**GENOA CHARTER TOWNSHIP
PLANNING COMMISSION PUBLIC HEARING
NOVEMBER 13, 2017
MONDAY
6:30 P.M.
AGENDA**

Attention:	Kelly Van Marter, AICP Planning Director and Assistant Township Manager
Subject:	Brighton Church of the Nazarene – Site Plan Amendment (Review #2)
Location:	7669 Brighton Road – northwest corner of Brighton and Aljoann Roads
Zoning:	SR Suburban Residential

Request to Amend the Approved Site Plan

FULL PLAN VIEW
NOT TO SCALE

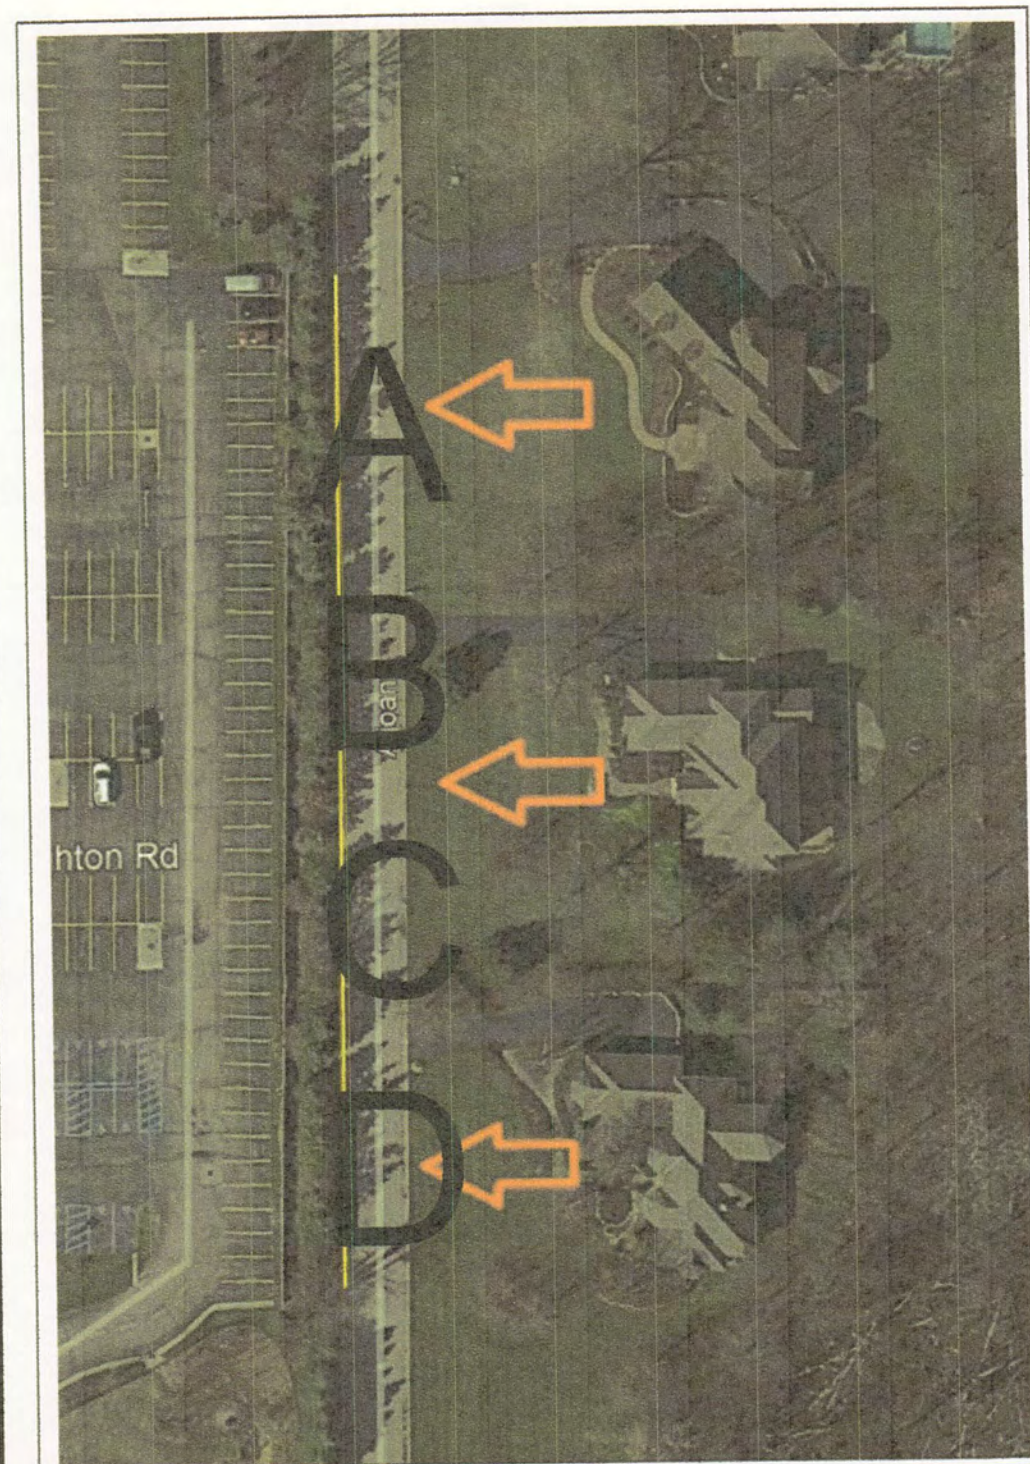
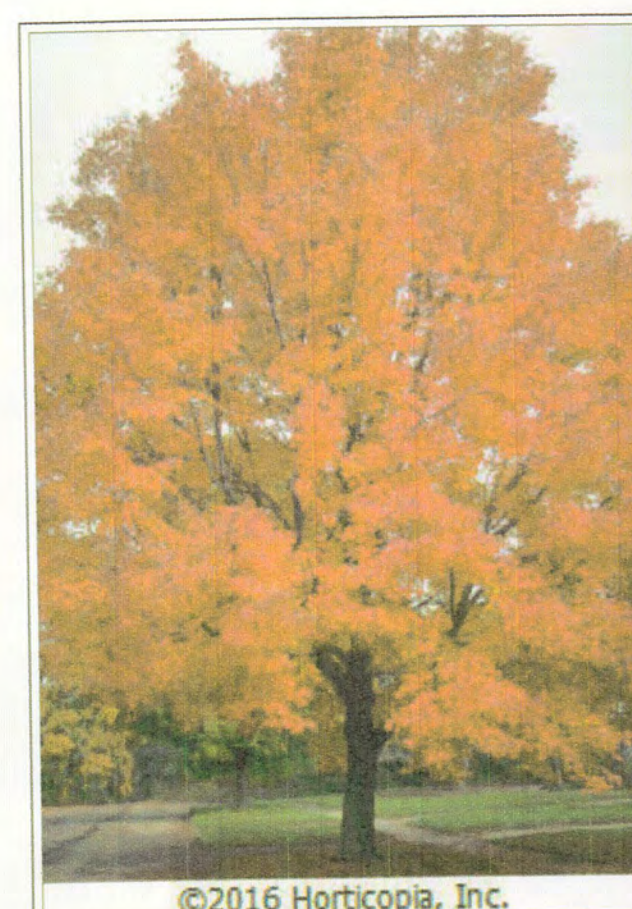
Our only comment is that the size noted for the deciduous trees (1.5-2" caliper) is smaller than the minimum Ordinance standard (2.5" caliper). The applicant needs to increase the size of the proposed deciduous trees.

*NOTE: BUILDING ADDRESS SHALL BE A MINIMUM OF 6" HIGH LETTERS OF CONTRASTING COLORS AND BE CLEARLY VISIBLE FROM THE STREET.

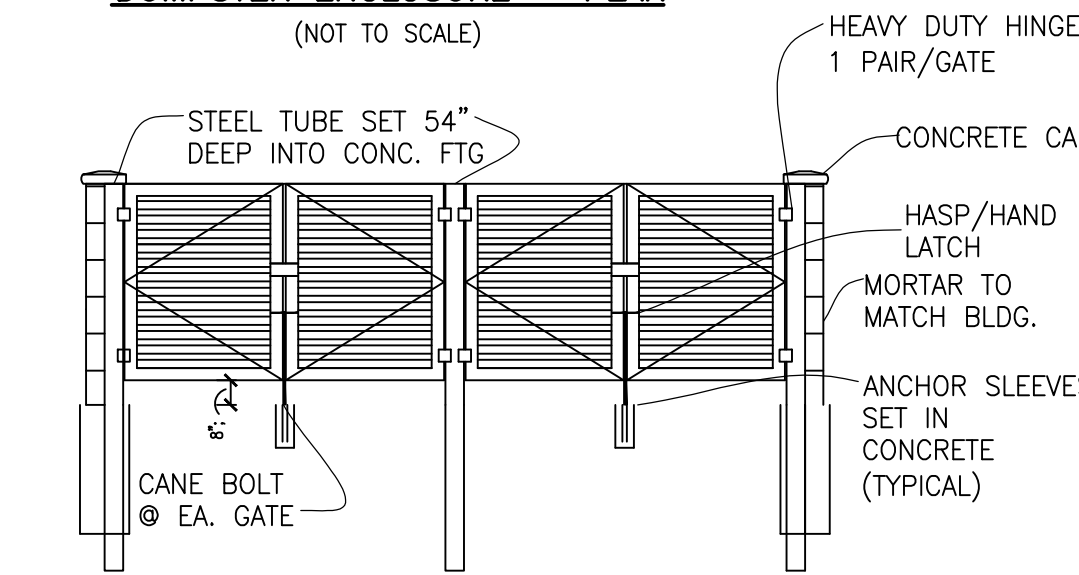
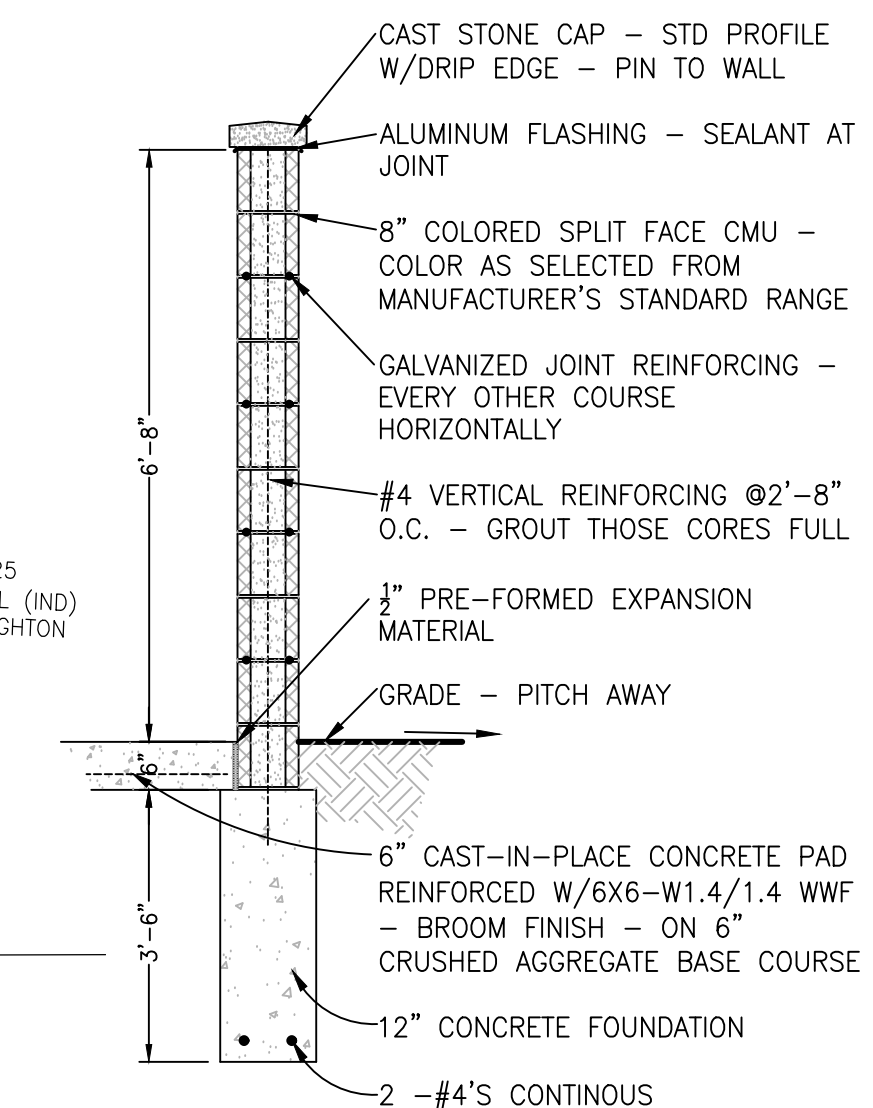
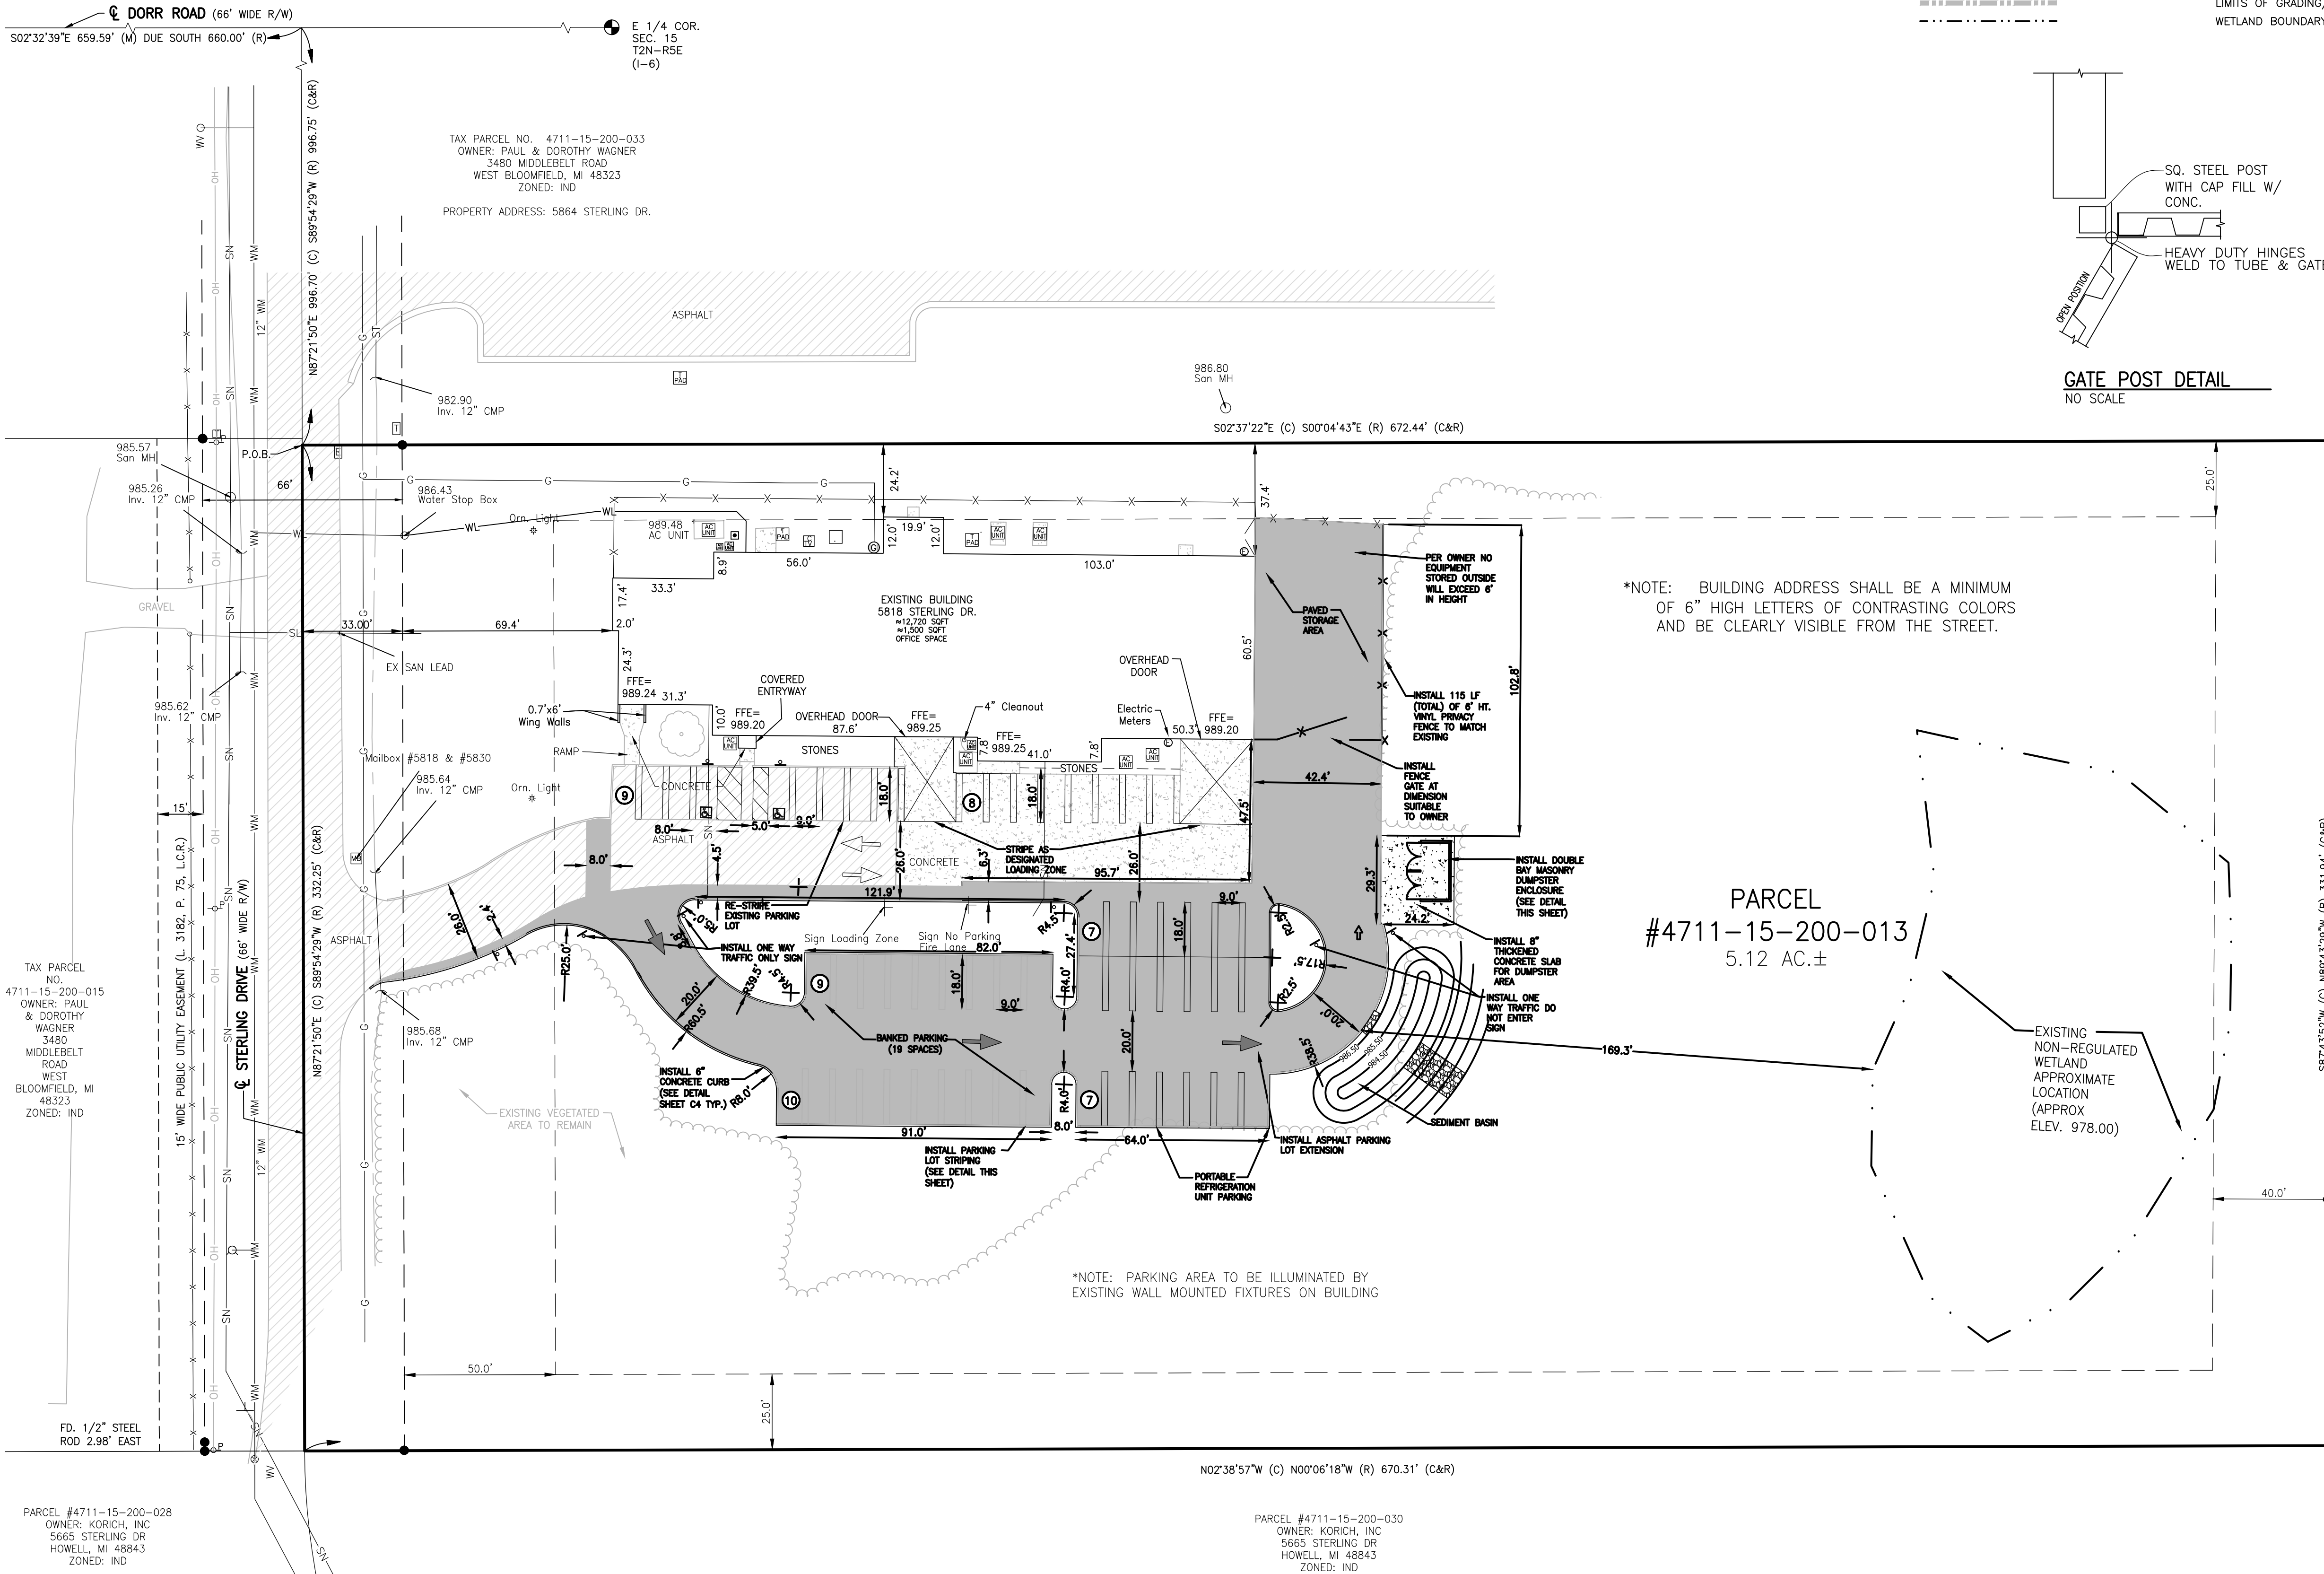
1. **(CORRECTED)** The building address shall be a **minimum of 6"** high letters of contrasting colors and be clearly visible from the street. The location and size shall be verified at inspection. **(Address improvement noted on Sheet C3)**

DESIGNED BY: AEB
 CHECKED BY: AEB
 SCALE: 1" = 30'
 JOB NO. 17-329
 DATE 10-3-17
 SHEET NO. C4

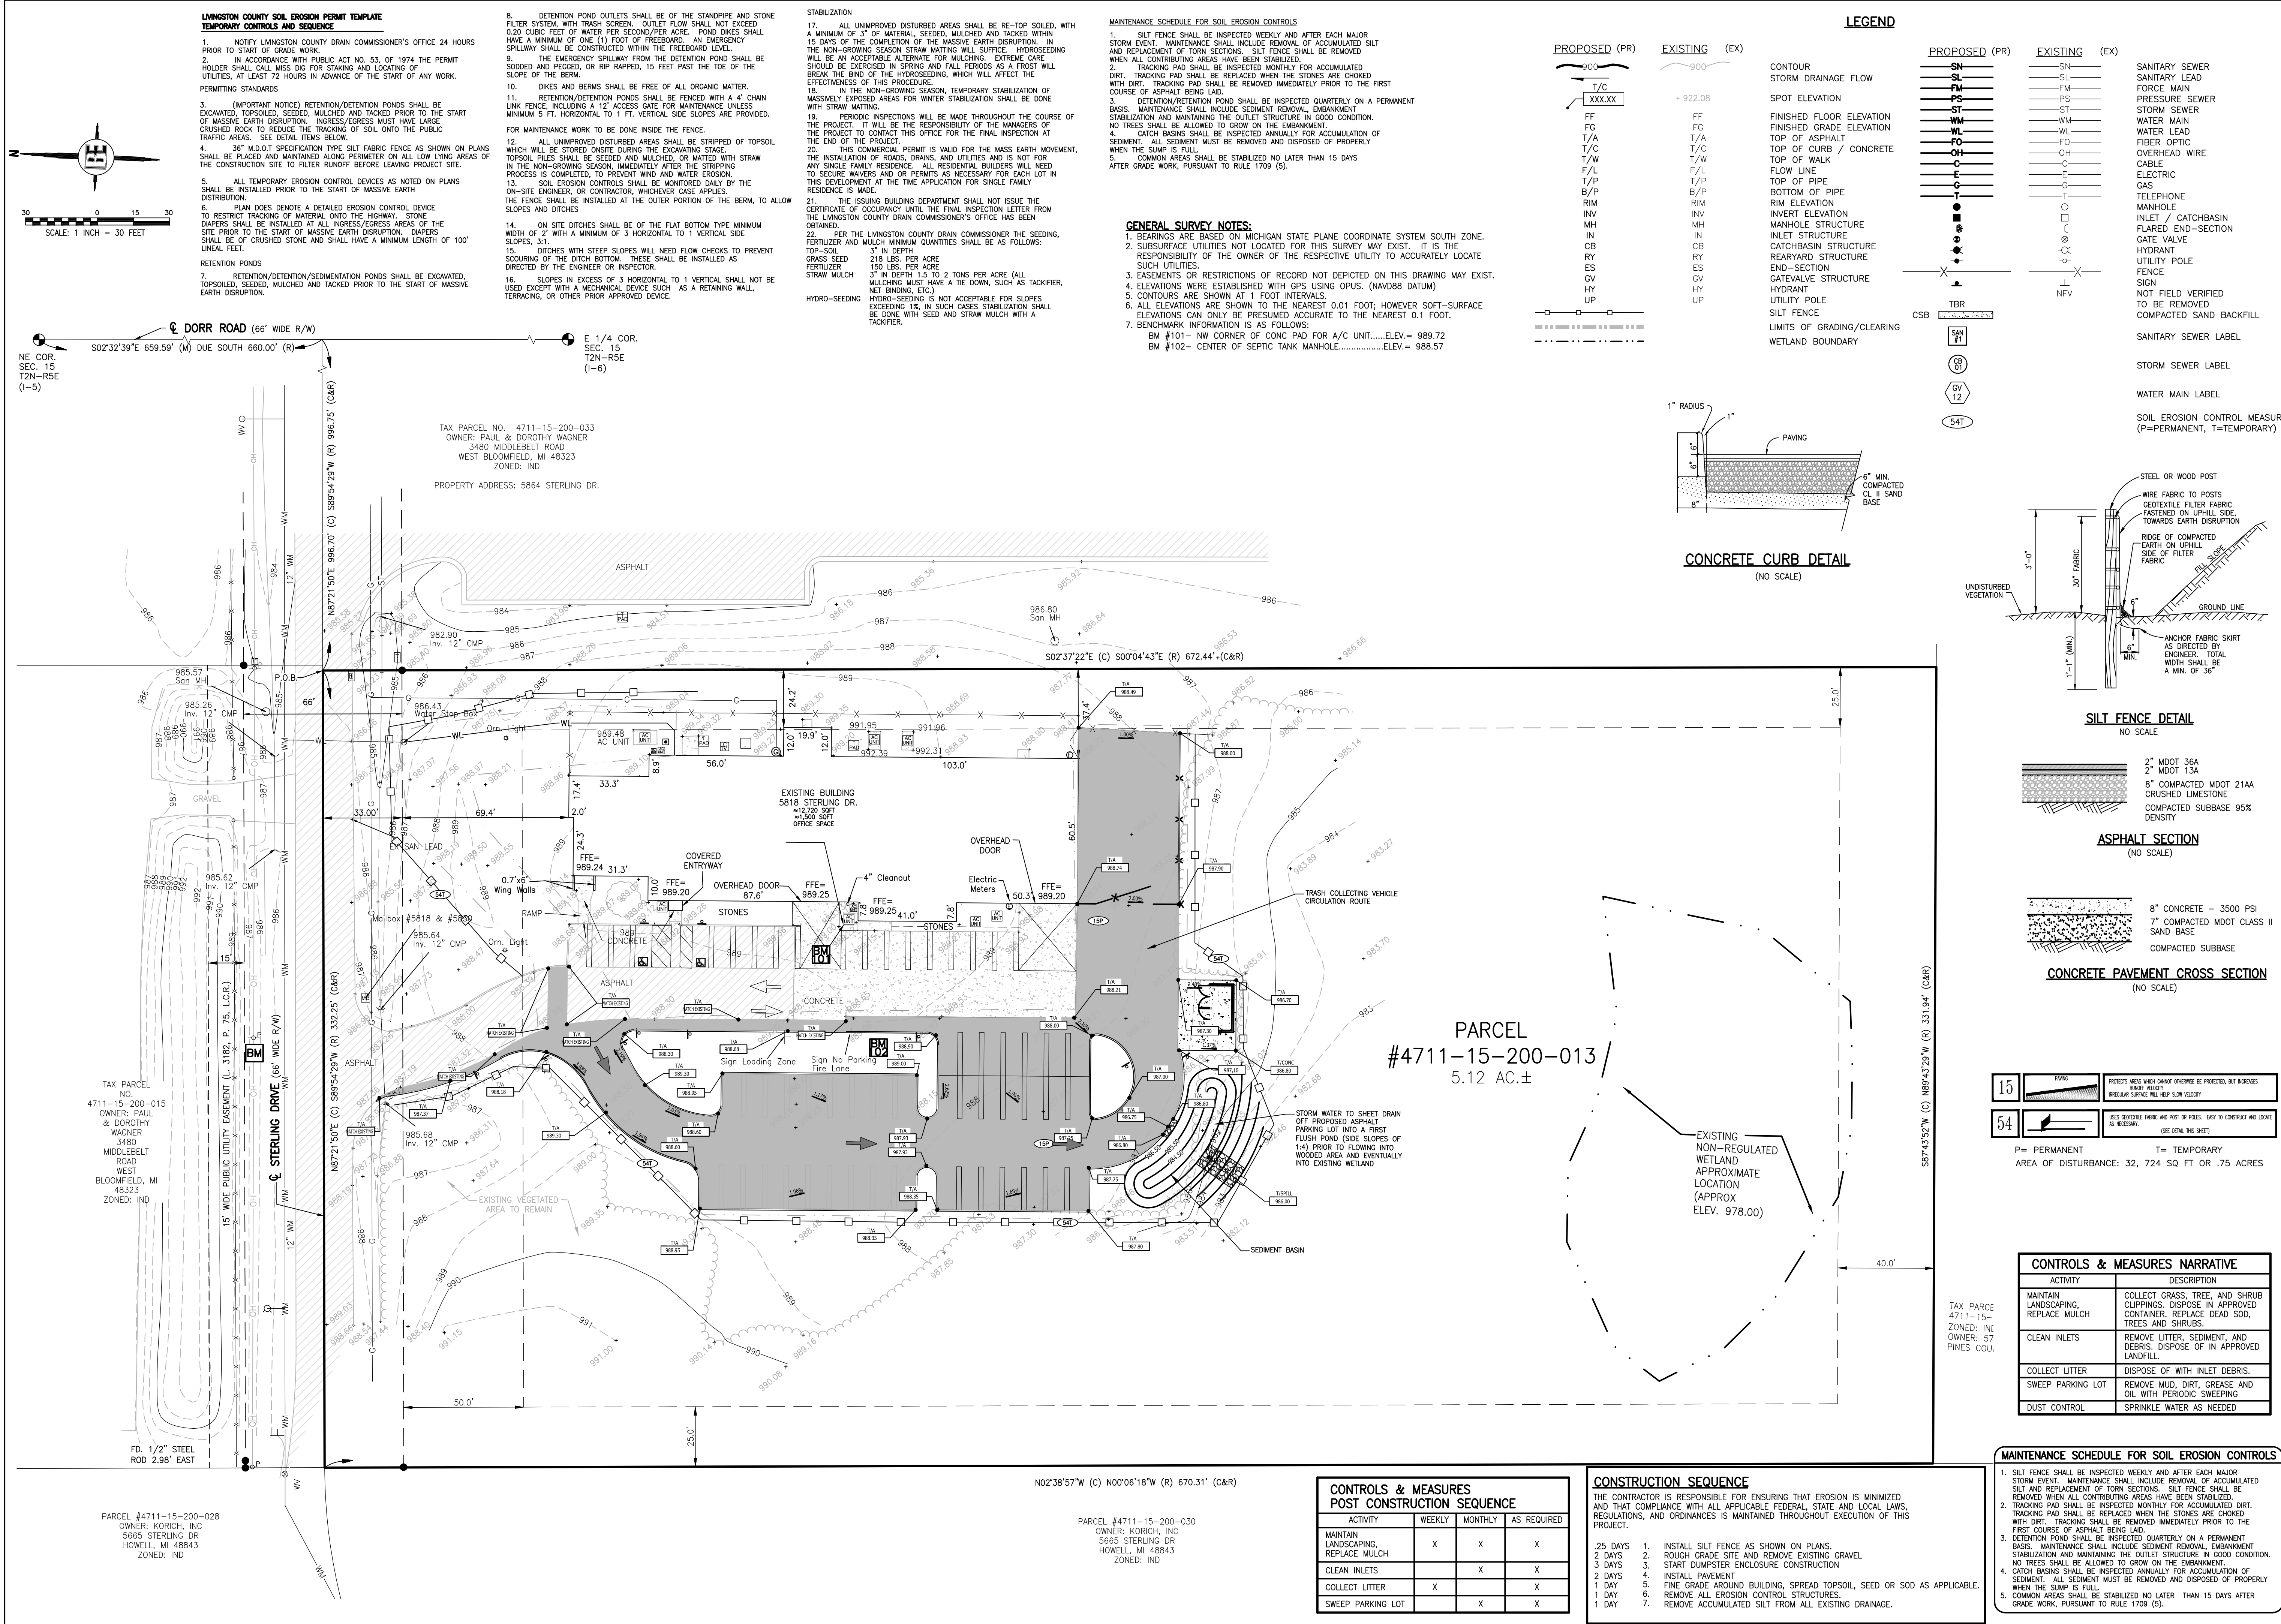
2. **(CORRECTED)** The existing two-way access drive adjacent to the structure shall be a minimum of 26' wide and is currently shown at 21' for the front portion of the landscape island then widens to 24' towards the rear. With a width of 26' wide, the landscape island side of the drive shall be marked as a fire lane. Access roads to site shall be provided and maintained during construction. Access roads shall be constructed to be capable of supporting the imposed load of fire apparatus weighing at least 75,000 pounds. **(Sheet C3 reflects revision to the landscape island dimension to provide for width and proper turning radius. Fire lane signage is also noted.)**
